# Access Compliance Report

## Public Rights-of-Way

Intersection ID: 20325	Main Street: CREOLA_RD	Cross Street: PROVIDENCE_RD	Location: SW
ADA ID: 655D84B18C96	Ramp Type: Perpendicular Diagonal	Initial Pass/Fail: Fail	Overall Compliance: No
		Severity Score: 12.5

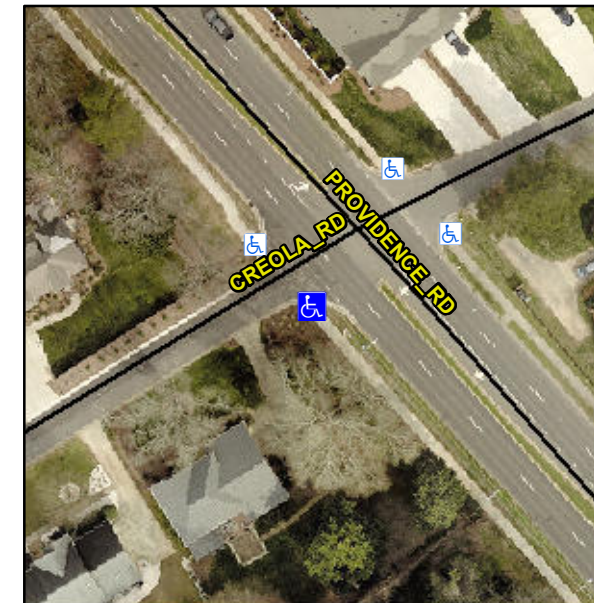
Compliance	Description	Data	Compliance	Description	Data
N/A	Ramp Length (in)	74.0	No	Ramp Slope (%)	9.6
Yes	Ramp Width (in)	94.0	Yes	Ramp XSlope (%)	1.1
N/A	Flare Type LT	N/A	N/A	Flare Type RT	N/A
N/A	Flare Slope LT (%)	N/A	N/A	Flare Slope RT (%)	N/A
N/A	Flare Traversable LT?	N/A	N/A	Flare Traversable RT?	N/A
N/A	Landing Length (in)	N/A	N/A	DWS Provided?	N/A
N/A	Landing Width (in)	N/A	N/A	DWS Contrast?	N/A
N/A	Landing Slope (%)	N/A	N/A	DWS Length (in)	N/A
N/A	Landing X Slope (%)	N/A	N/A	DWS Full Width?	N/A
N/A	Landing Curb? (Y/N)	N/A	N/A	DWS Offset (in)	N/A
N/A	Shared Landing?	N/A			
N/A	Gutter Ponding?	N/A	N/A	Gutter Slope (%)	N/A
N/A	Gutter Lip Ht (in)	N/A	N/A	Gutter X Slope (%)	N/A
N/A	Painted X Walk1?	No	N/A	Painted X Walk2?	No
	X Walk 1 Direction	To NE		X Walk 2 Direction	To NW
N/A	X Walk 1 Width (in)	N/A	N/A	X Walk 2 Width (in)	N/A
	X Walk 1 Slope (%)	0.8		X Walk 2 Slope (%)	4.4
	X Walk 1 X Slope (%)	2.6		X Walk 2 X Slope (%)	1.0

**Remove & Replace Curb Ramp With Two New Directional Ramps or Equivalent.**

**R304.2.2**
